United States Patent and Trademark Office

| APPLICATION NO. | FILING DATE | FIRST NAMED INVENTOR | ATTORNEY DOCKET NO. | CONFIRMATION NO. | |
|--|-----------------|-------------------------|---------------------|------------------|--|
| 10/003,370 | 11/15/2001 | Hamid S. Abroy | LEX-80 | 4701 | |

| | Application No. | Applicant(s) | | | |
|---|----------------------------------|--------------------------------|--|--|--|
| Office Action Summary | Examiner | Art Unit | | | |

DETAILED ACTION

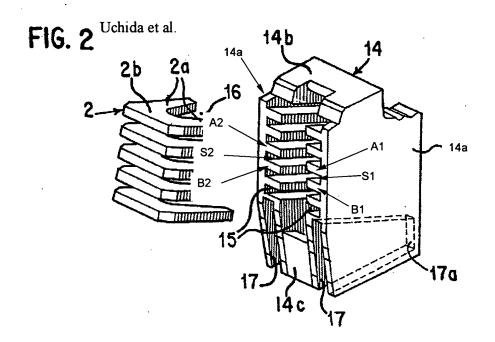
- 3. Claims 12 and 13 are rejected under 35 U.S.C. § 102(b) as being clearly anticipated by Uchida et al. Uchida et al. disclose an apparatus for quenching an arc (14) (Fig. 2), the apparatus having an arc stack housing (14); an arc plate (2) (Fig. 5); and a means (2c) for securing the arc plate in the arc housing; the means preventing the arc plate from vibrating in the arc stack

housing due to the alternating magnetic field caused by current flowing through the circuit breaker (Uchida et al.: col. 7, lines 33-44).

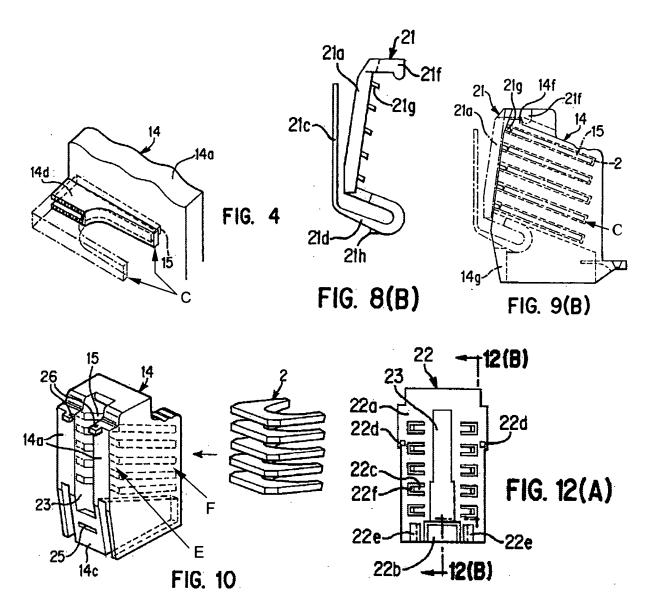
Claims 1 and 2 are rejected under 35 U.S.C. § 103(a) as being unpatentable over Uchida et al. Uchida et al. disclose an integrally molded housing (14) (Figs. 1 and 2) for securing an arc plate (2), the arc plate including a first longitudinal edge (2a), an opposed second longitudinal edge (2a), a notched first end (16), and a second end (2b) opposed to the first end, the housing having a first support member (14a); a second support member (14a) secured in a spaced relation to the first support member; a first securing ledge (A1) protruding from the first support member and toward the second support member; the first securing ledge having a lower surface; a second securing ledge (B1) protruding from the first support member and toward the second support member and having an upper surface, the first securing ledge lower surface and the second securing ledge upper surface defining a first slot (S1) adapted to receive the first longitudinal edge of the arc plate; a third securing ledge (A2) protruding from the second support member and toward the first support member; the third securing ledge having a lower surface; a fourth

securing ledge (B2) protruding from the second support member and toward the first support member and having an upper surface, the third securing ledge lower surface and the fourth securing ledge upper surface defining a second slot (S2) adapted to receive the second longitudinal edge of the arc plate; a stop member (C) engaging the first end of the arc plate; and a locking member (21g) (Figs. 8B and 9B) engaging the second end of the arc plates. In specific regards to claim 2, Uchida et al. further disclose an additional embodiment having resilient stop members (21c) (Figs. 12A-12D) with tabs (21f) engaging the first end of the arc plates, fixing them in place. Uchida et al. disclose the claimed invention except for the back stop being resilient. It would have been obvious to one having ordinary skill in the art at the time the invention was made to reverse the resilient nature of the back stop with that of the locking member, since it has been held that a mere reversal of the essential working parts of a device involves only routine skill in the art. In re Einstein, 8 USPQ 167.

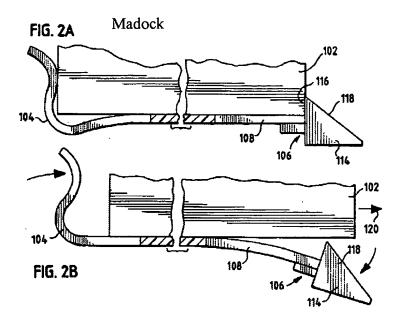
6. Claims 3 and 4 are rejected under 35 U.S.C. § 103(a) as being unpatentable over Uchida et al., as applied to claim 1 above, and in further view of Madock. Uchida et al. disclose a housing for securing an arc plate having all the elements stated previously. Although Uchida et al. disclose an integrally molded housing, Uchida et al. do not expressly disclose an integrally molded housing for securing an arc plate wherein the locking member further having a resilient

member having a first end fixedly attached to the first securing ledge and having a second end connected to the tab, the tab having an inside face for securing the arc plate in the housing; and wherein the first support member, the second support member, the first securing ledge, the second securing ledge, the stop member, and the locking member form an integral molded assembly. Madock teaches a housing (Figs. 1-7) capable of securing an arc plate having integrally molded supports (12) having resilient stop members (104); locking members (106) including a resilient member (108) and a tab (114), the resilient member having a first end fixedly attached to a first securing ledge (82-90) and having a second end connected to the tab, the tab having an inside face (116) for securing an arc plate in the housing. It would have been obvious to one having ordinary skill in the art at the time the invention was made to employ the integrally molded supports with all of the elements taught by Madock, modifying the integrally molded housing, the stop members, the locking members and securing ledges, disclosed by Uchida et al., thus forming an integrally molded assembly consisting of support members, securing ledges, stop members and locking members, thereby substantially reducing the cost of manufacturing of the housing (Madock: col. 4, lines 31-34), as well allowing for the partial ejection of the arc plate from the housing so that it may be easily grasped by a user (Madock: col. 1, lines 39-42). In further regards to claim 4, it would have been obvious to one having ordinary skill in the art at the time the invention was made to form the apparatus and all of the elements disclosed by Uchida et al. and Madock, since it has been held that forming in one piece an article which has formerly been formed in two pieces and put together involves only routine skill in the art. Howard v. Detroit Stove Works, 150 U.S. 164 (1893).
